# PLANNING AND ZONING CASE CHECKLIST

**Project Number: SP2019-044**  
**Project Name: Office Complex**  
**Project Type: SITE PLAN**  
**Applicant Name: ROSS RAMSAY**  
**Owner Name: JIMMY MCCLINTOCK**

**Project Description: Discuss and consider a request by Steven Reyes of Ramsay & Reyes, LLC on behalf of Jimmy McClintock of LMGC, LLC for the approval of a site plan for an office building on a 0.739-acre tract of land identified as a portion of Lot 14 of the Lowe & Allen Addition [0.4590-acres] and Lot 2-R, Block A, Washington Place Addition [0.28-acres], City of Rockwall, Rockwall County, Texas, zoned Downtown (DT) District, situated within the SH-66 Overlay (SH-66 OV) District, addressed as 409 W. Washington Street, and take any action necessary**

**TO:** Planning and Zoning Commission  
**DATE:** January 14, 2020  
**APPLICANT:** Steven Reyes; *Ramsay and Reyes Architecture, LLC*  
**CASE NUMBER:** SP2019-044; *Site Plan for 409 W. Washington Street*

DRAWING NAME:  
**SITE PLAN**

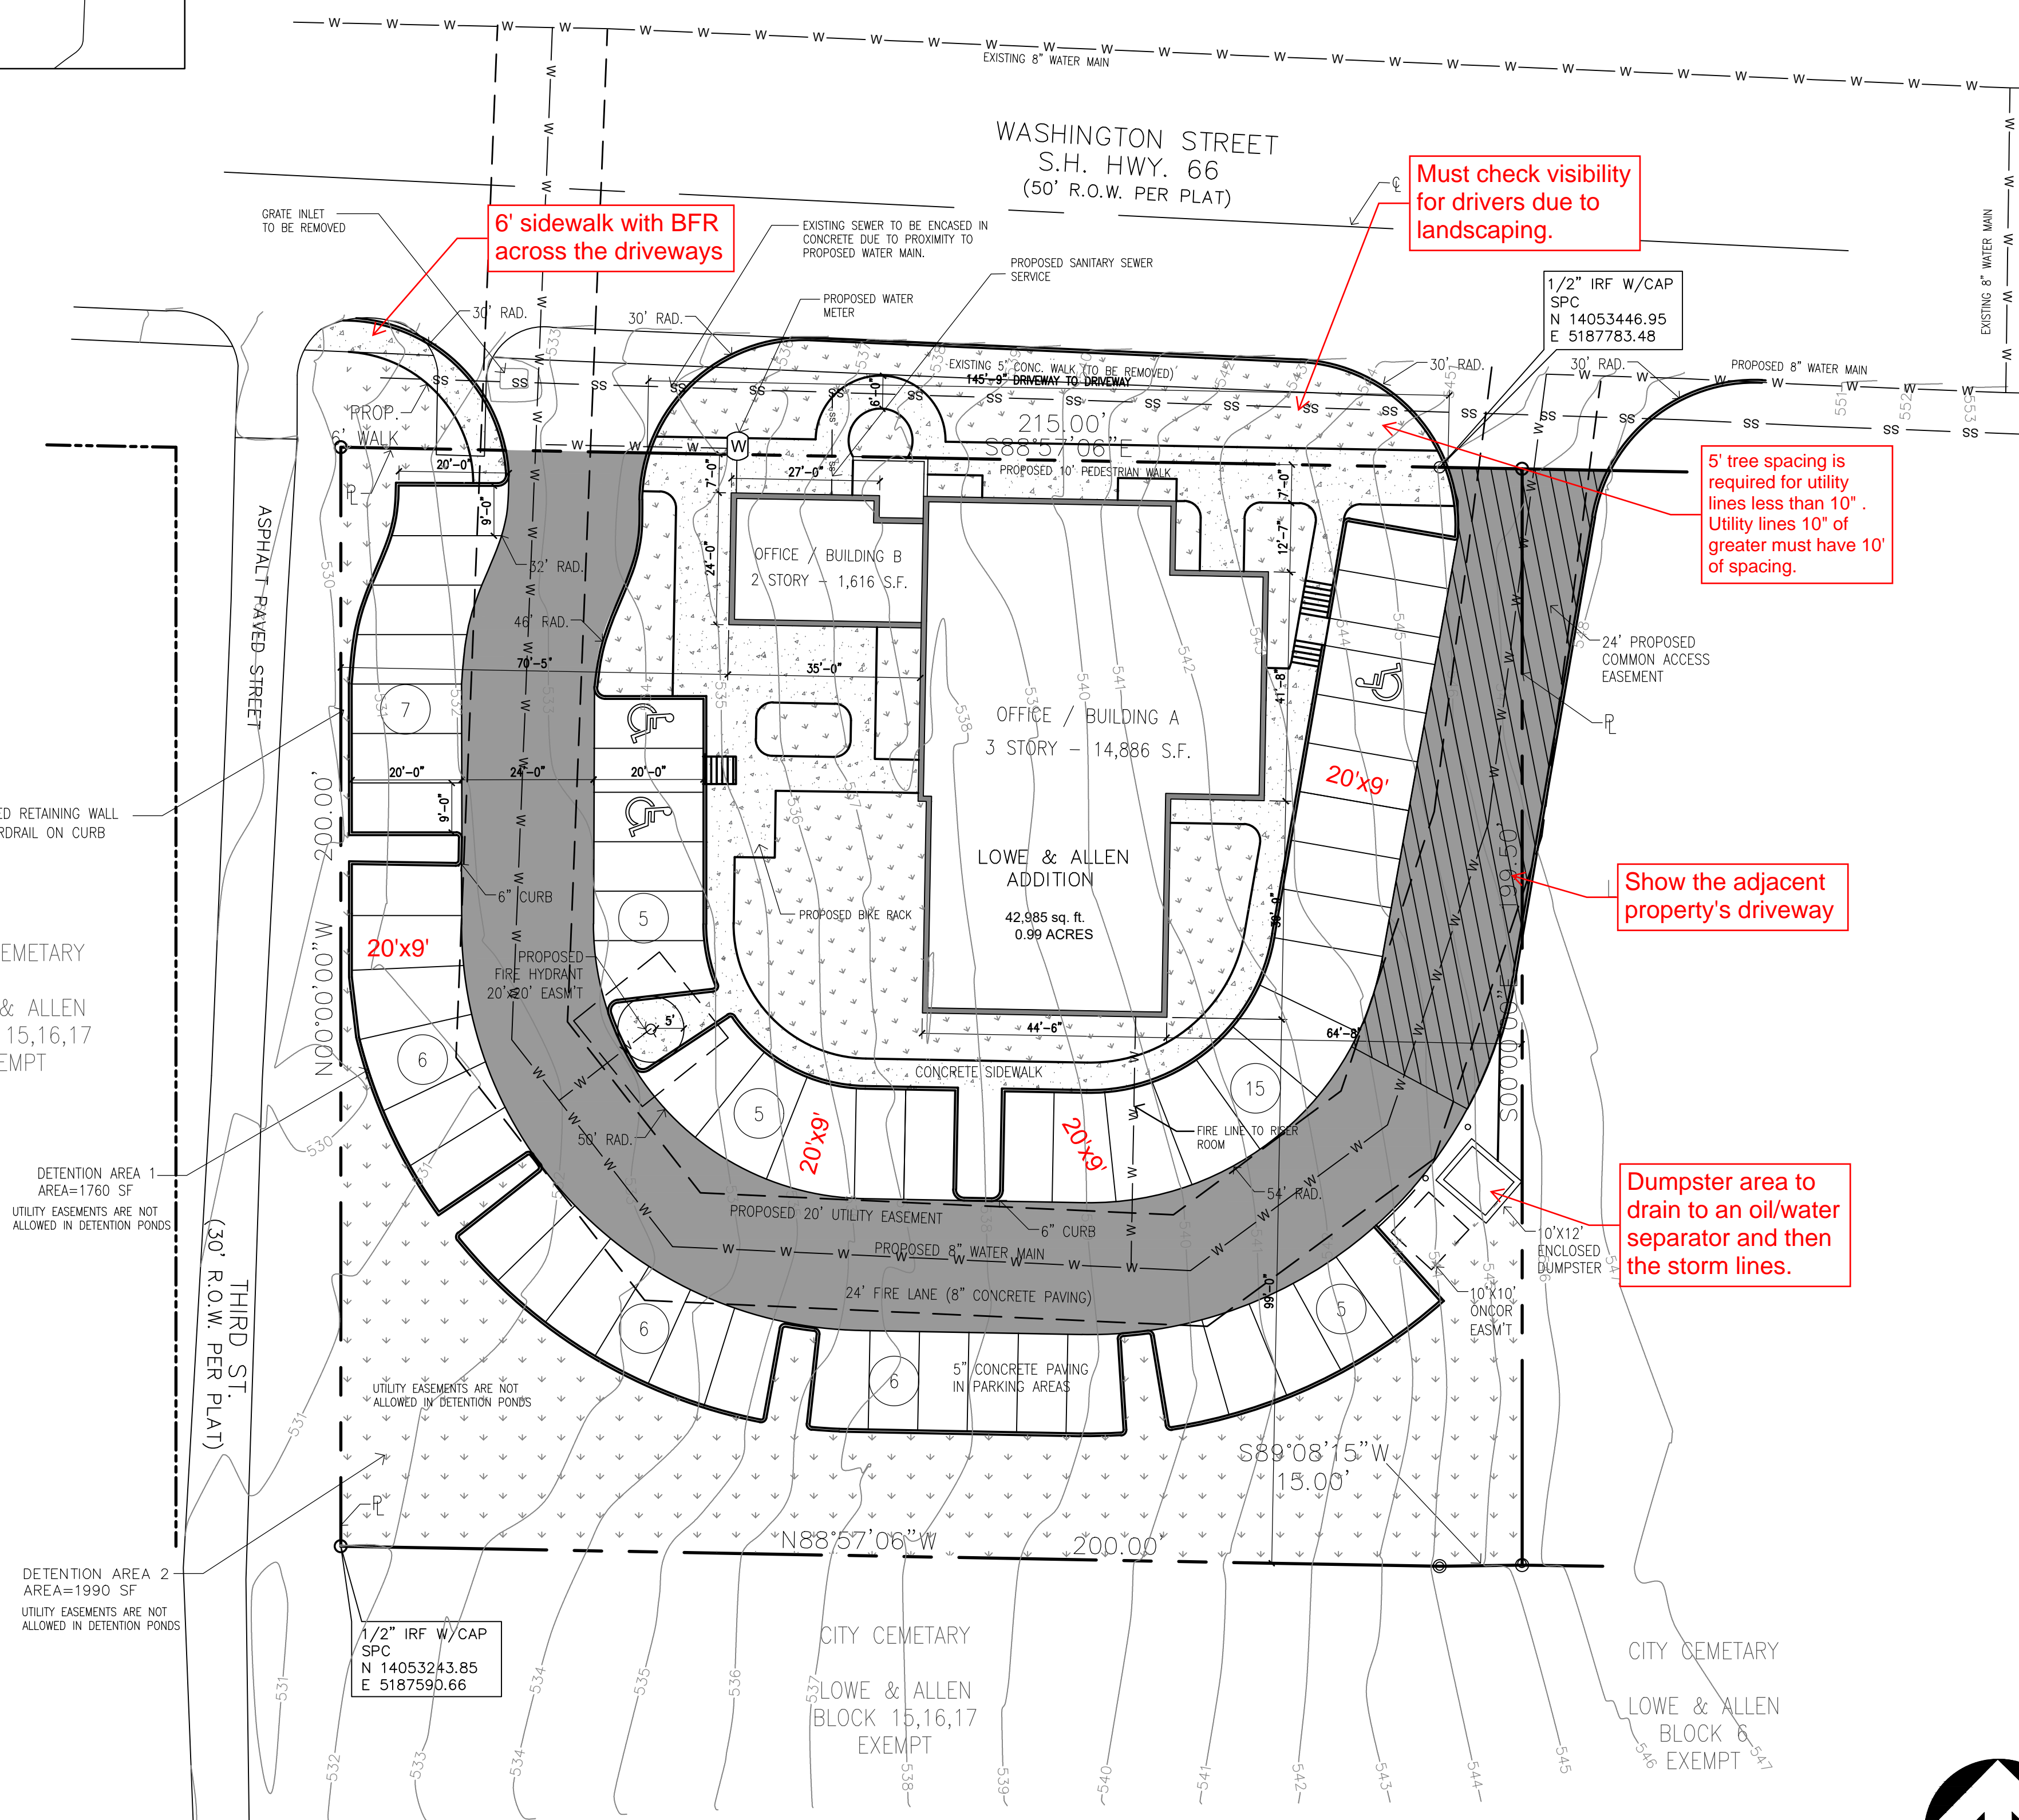
- 4% Engineering inspection fees (i)
- Impact fees. (i)
- Min 20' utility easements. (i)
- No structures in easements. (m)
- Fire lane to be 24' wide with 20' radii (or 30' rad. depending on height). (m)

- Parking to be 20'x9' (m)
- Dumpster area to drain to oil/water separator or grease trap, depending on use. (m)
- No trees within 5' of public utilities. (m)

- Detention outfall must reach sheet flow conditions prior to crossing the property line. (i)
- Engineering review fees apply (i)
- No walls in utility esmts (m)

- Must meet all city engineering standards. (m)

6' sidewalk with BFR across the driveways

Must check visibility for drivers due to landscaping.

Show the adjacent property's driveway

Dumpster area to drain to an oil/water separator and then the storm lines.

DRAWING NAME:  
**SITE PLAN**

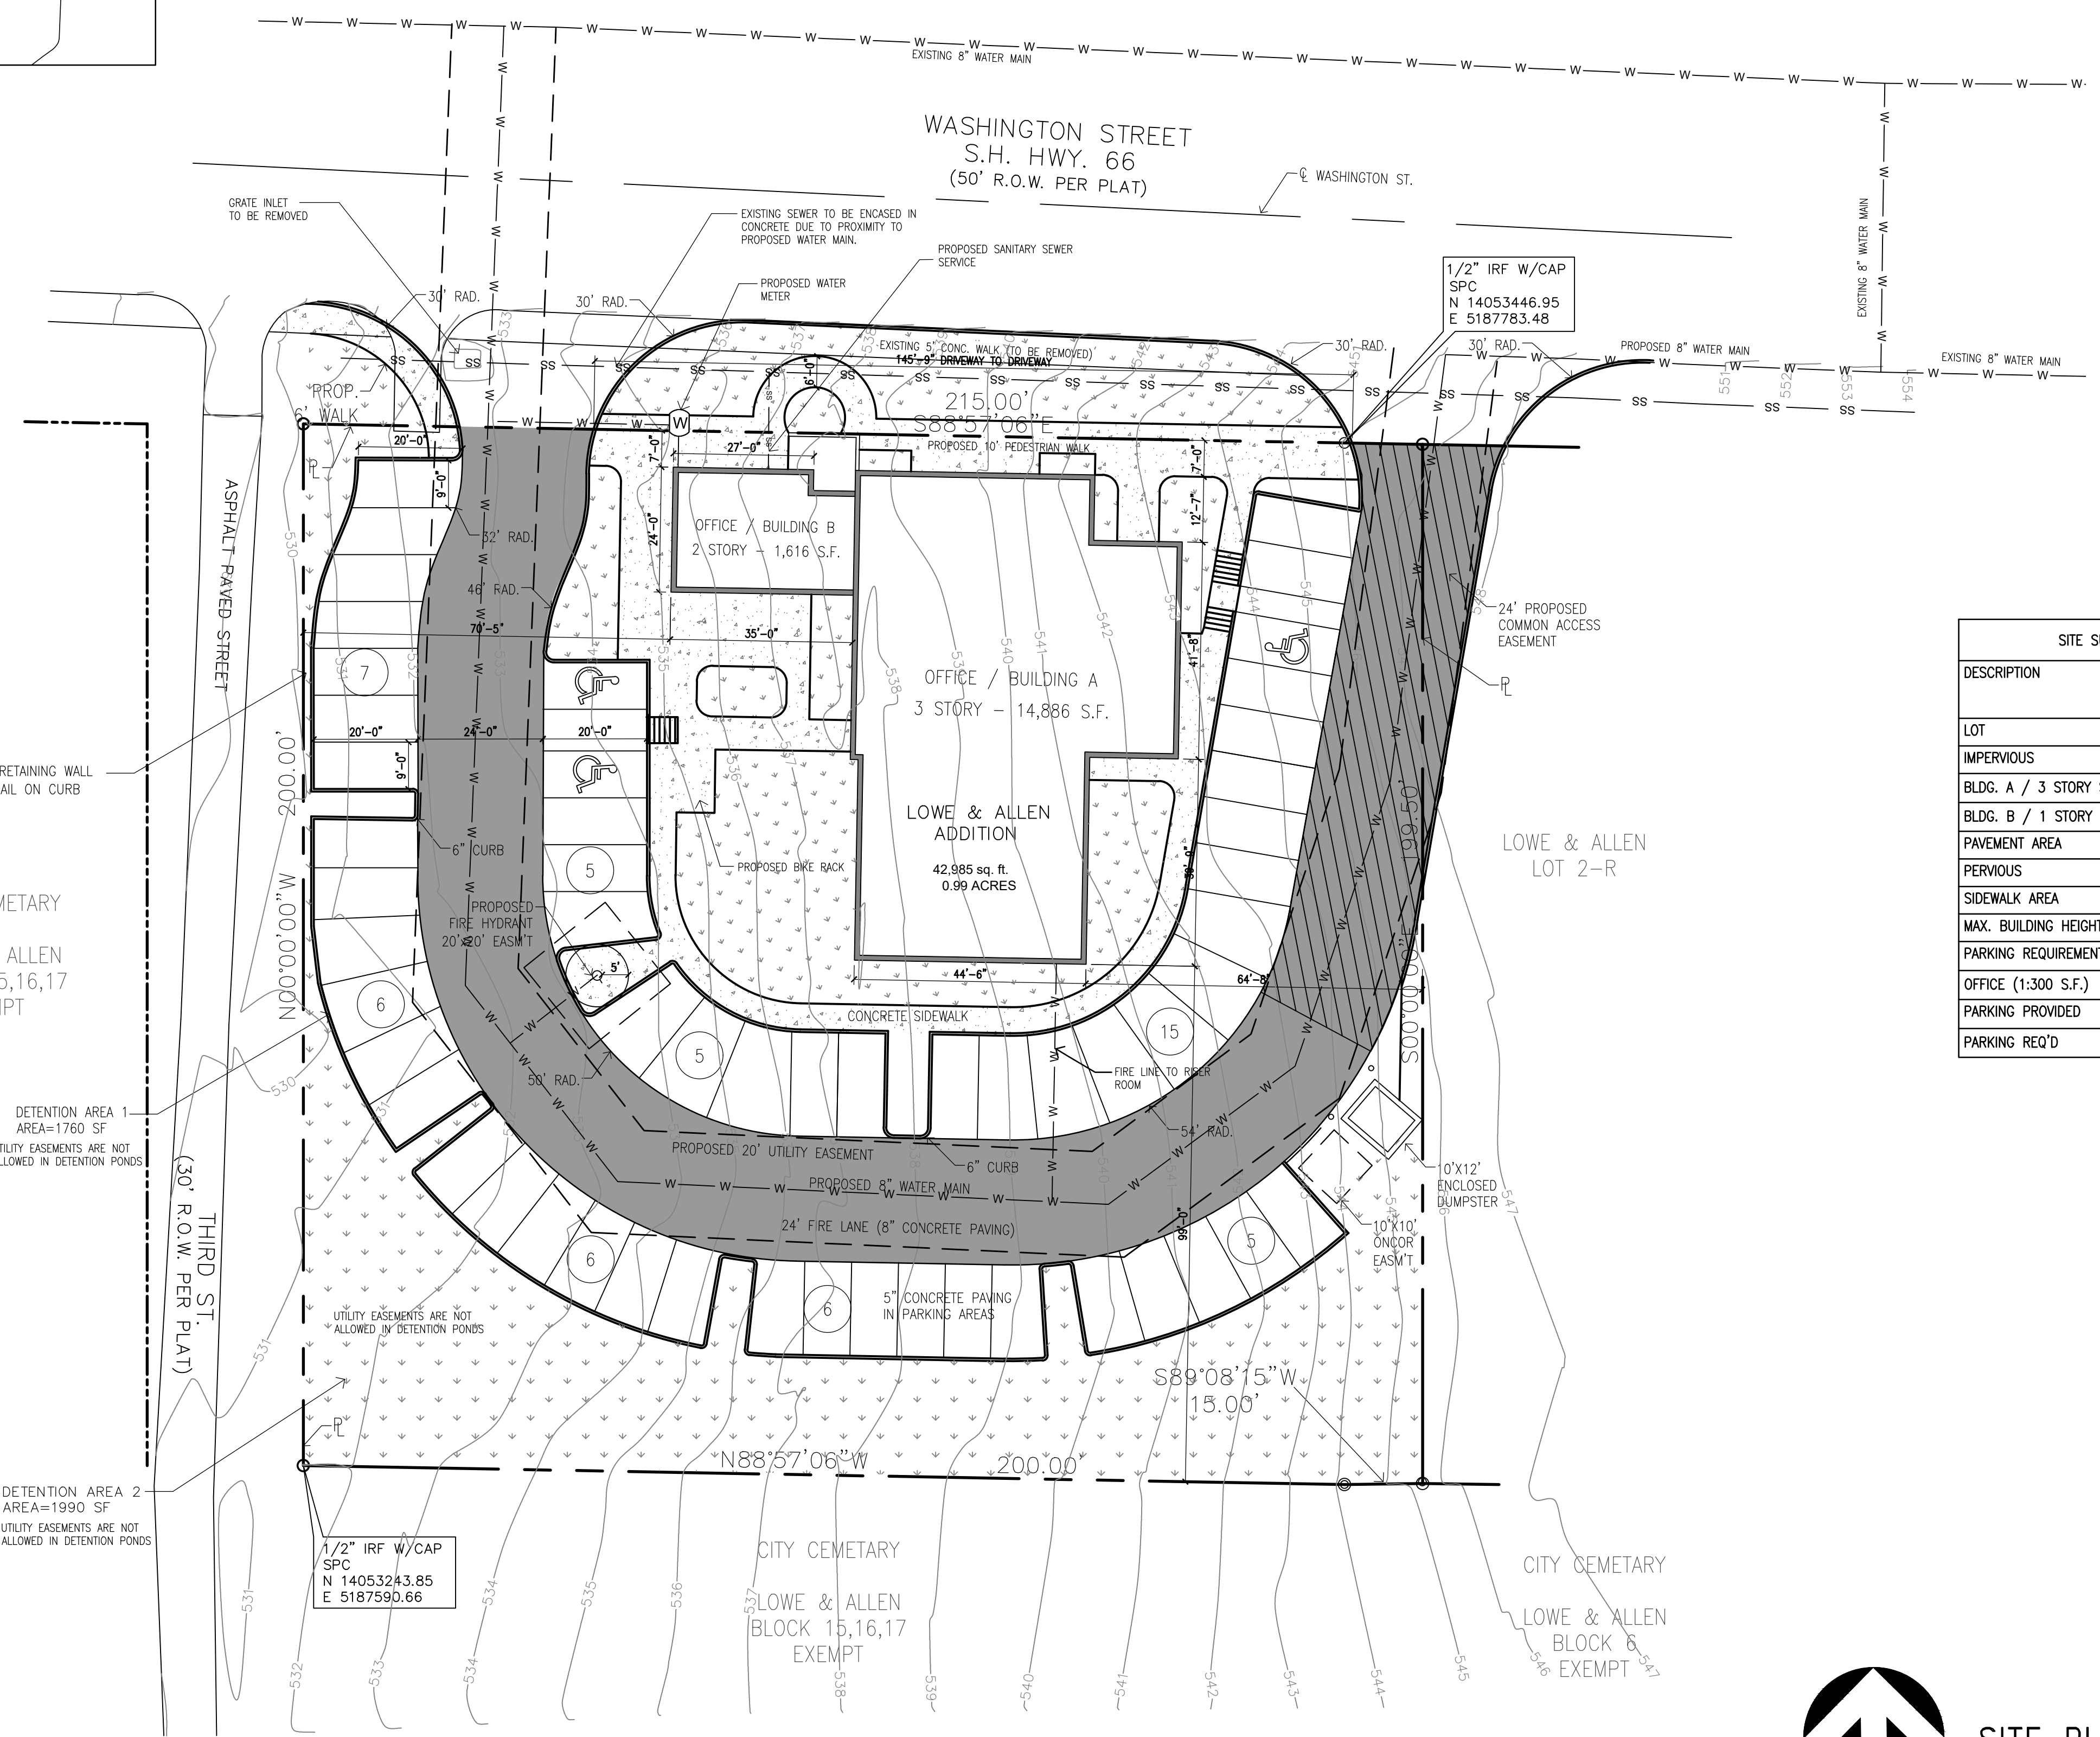
(1) Please do not provide a separate page for utilities. Please show on site plan and landscape plan.						
(2) Please show topo on site plan and landscape plan.

(3) Please remove labels for Lots 1R and 2R and provide existing lot and block information on site plan.						
(4) Please correct address on plans. Some plans indicate 409 W Washington and some indicate 411 W. Washington.

(5) Please provide site data table on site plan.						
(6) Please show centerlines of adjacent roadways.						
(7) Please note that all plans need to match (i.e. currently the utility plan does not match site plan.

(8) Please note that the water line will need to be looped through the site.						
(9) Please check the orientation of the stairs on the site plan.

(10) Please remove the concrete planter from the parking space						
(11) Please remove signage from the site plan.						
(12) Please utilize a variety of line types and line weights. It is difficult to determine what the lines are (i.e. there are several lines running N/S adjacent to the concrete planter)

(13) Please note that the dumpster enclosure cannot face the street. Also, a detail has been provided.						
(14) Please dimension a typical parking space.

(15) Please check radii at drive aisles to ensure conformance to the engineering standards of design.						
(16) Please show and label the property line.

(17) Please show FL with a hatch pattern, stipple, shade of gray, etc.						
(18) Please provide pavement type and depth.						
(19) Please show proposed sidewalks as a hatch pattern.

(20) Please dimension distance of building from property lines.						
(21) Please note, the site plan, building elevations, rendering do not seem to match. (i.e. the site plan shows projections/recesses adjacent to Washington Street that do not appear in the rendering and building elevations.

(22) Please provide all engineering information on site plan.						
(23) Please provide treescape plan						
(24) Please note that walls in the detention area will require a variance.
